Item ID: D206-667-107BL Accept ***N900040100*** Setup Start ***NS1***
Revision ID: Stop ***NS2***
Item Name: Fwd Crosstube - Mid Height 206L / L1 / L3 / L4, Blue
Start Date: 4/17/2017 Start Qty: 1.00 ***1*** Cust Item ID:
Required Date: 5/2/2017 Req'd Qty: 1.00 ***1*** Customer:
Reference: SCHEDULED/U DAS 21 3-89
Approvals: Process Plan: _____ Date: APR 06 2017 Tooling: _____ Date: _____ Run Start ***NR1***
QC: _____ Date: _____ SPC (Y/N): _____ Date: _____ Stop ***NR2***

DART AEROSPACE LTD		Work Order: 159213
Description: Crosstube Mid Fwd (206L)		Part Number: D206-667-107
Inspection Dwg: D206-667-147	Rev: A	Page 1 of 1

D206-667-147
ASSEMBLY DETAIL
 (VIEW LOOKING FWD)

DRAWING NO. D206-667-147	TITLE CROSSTUBE ASS'Y (206L MID FWD)	REV. A	DART AEROSPACE LTD ENGINEERING ORDER		D.E.O. NO. D206-667-147-A-1	SHEET NO. SHEET 1 OF 1	SCALE NTS
DRAWN <i>q</i>	CHECKED <i>ASS</i>	MFG. APPR. <i>JB</i>	APPROVED <i>MD</i>	DE APPR. <i>MD</i>			
DATE 11.07.15	DATE 11.07.20	DATE 11.07.21	DATE 11/07/21	DATE 11.07.21

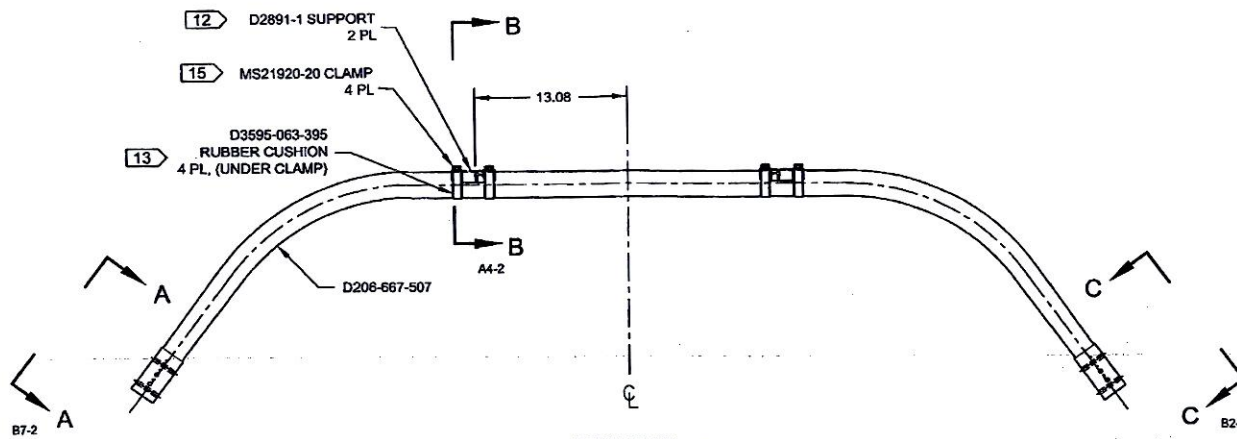
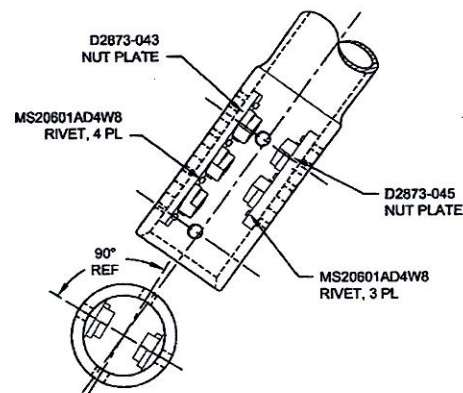
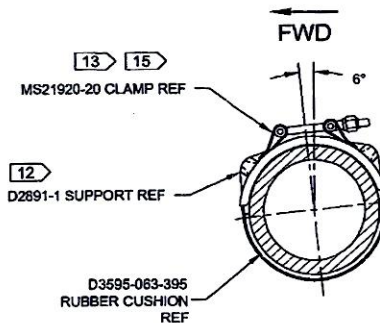
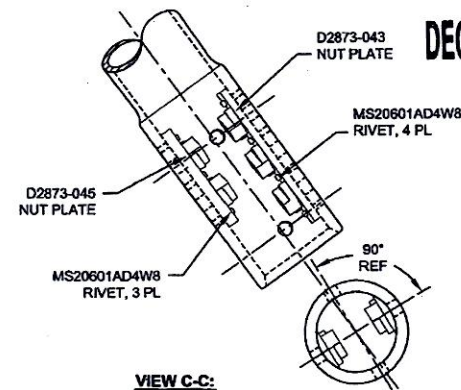
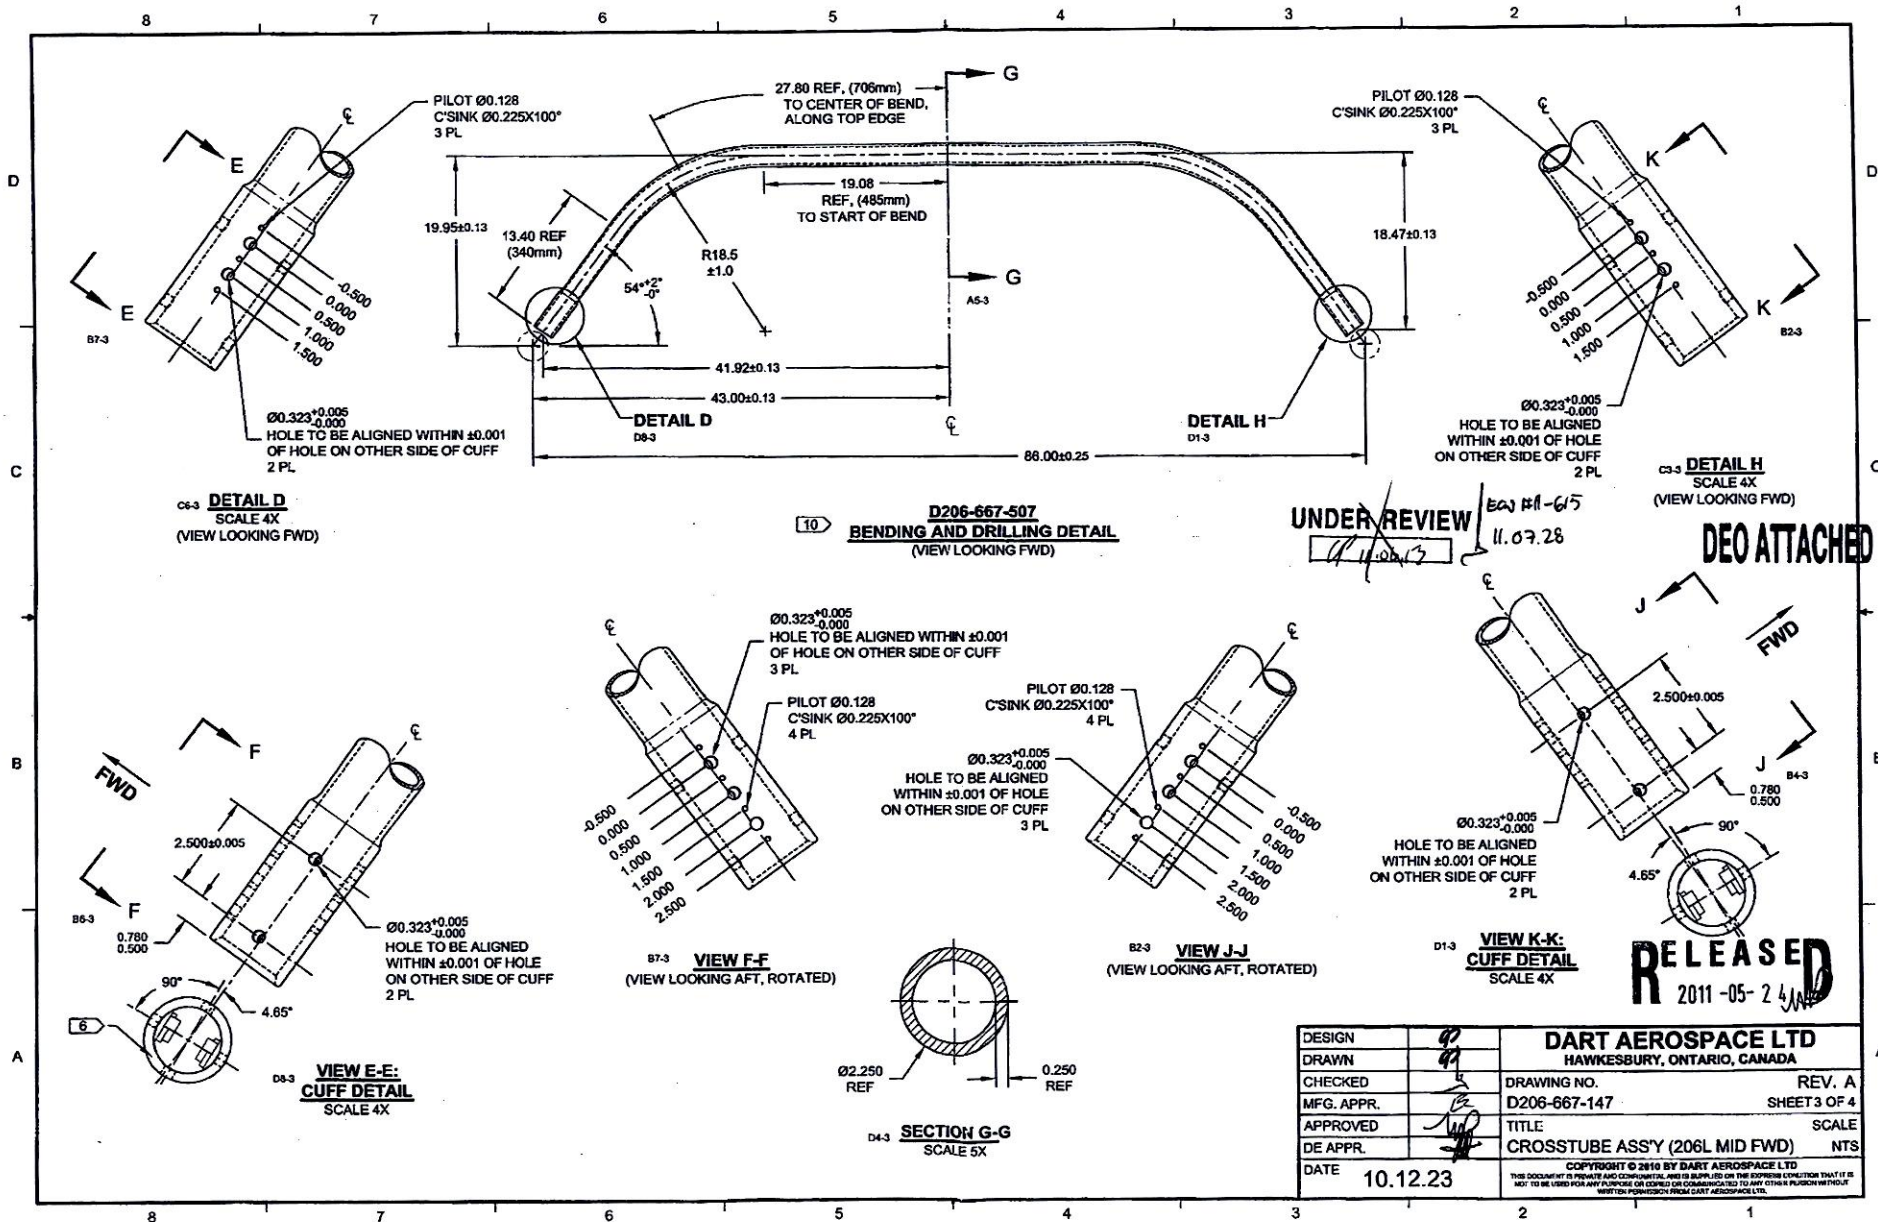
PURPOSE:

REPLACE MAGNOBOND WITH PROSEAL.

NOTE 12 & 15, SHEET 1 IS AMENDED AS FOLLOWS:

Item	Qty -147	Part Number	Description
9	A/R	PROSEAL 890 B-2	SEALANT, AMS-S-8802 CLASS B-2

- 12) TO INSTALL D2891-1 SUPPORT: ABRAD MATING SURFACE OF SUPPORT AND CROSSTUBE WITH 180-GRIT SANDPAPER AND REMOVE RESIDUE WITH MEK (OR EQUIVALENT). APPLY A 0.04" TO 0.07" THICK LAYER OF PROSEAL 890 CLASS B-2 (OR AMS-S-8802 CLASS B-2) SEALANT TO MATING SURFACE OF SUPPORT.
- 15) TORQUE CLAMPS 80 TO 100 IN-LB. ENSURE AT LEAST 1.5 THREADS SHOWING IN SAFETY AND THAT NUT HAS NOT BOTTOMED-OUT AFTER TORQUING. **PRIOR TO PACKAGING, RE-CHECK TORQUE ON CLAMPS AFTER PROSEAL 890 SEALANT HAS CURED FOR 72 HOURS.**

DETAIL P
BONDING STRAP INSTALLATION 2 PL

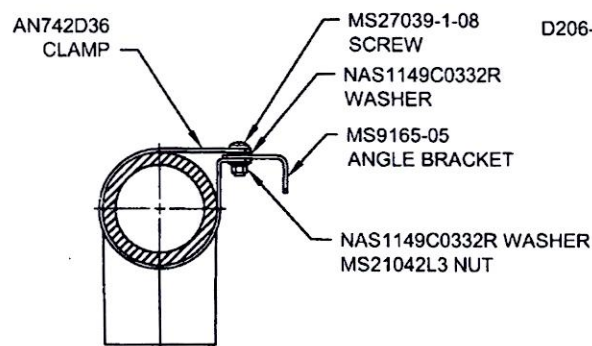
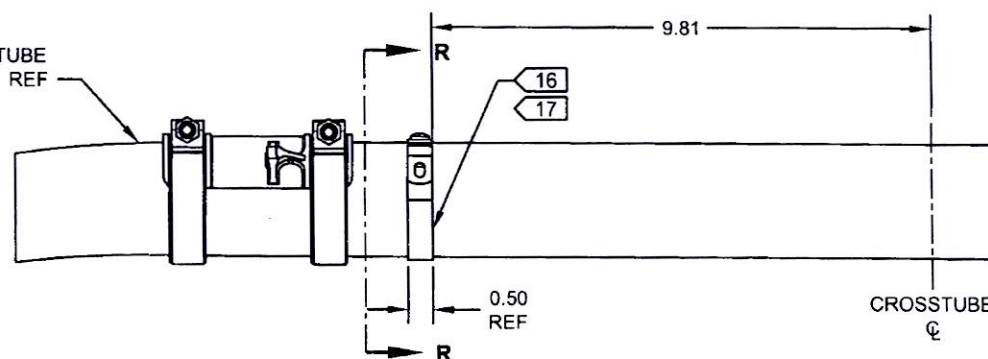
PURPOSE:

ADD ELECTRICAL GROUNDING STRAP

ITEM	QTY -147	PART NUMBER	DESCRIPTION	
1	X	D206-667-147	CROSSTUBE ASSEMBLY (206L MID FWD)	
10	2	AN742D36	CLAMP	} ADD
11	2	MS9165-05	ANGLE BRACKET	
12	2	MS21042L3	NUT (OR MS21042-3)	
13	2	MS27039-1-08	SCREW	
14	4	NAS1149C0332R	WASHER (OR AN960C10L)

- 16) MASK AREA UNDER CLAMP PRIOR TO PAINTING
17) SEAL EDGES WHERE AN742D36 CLAMP MEETS WITH THE CROSSTUBE USING SIKAFLEX-241/-291 OR MIL-S-8802 CLASS B2 OR PROSEAL 890 SEALANT
18) PERFORM RESISTANCE CHECK TO ENSURE MAX RESISTANCE IS 10 MILLIOHMS
- AFT
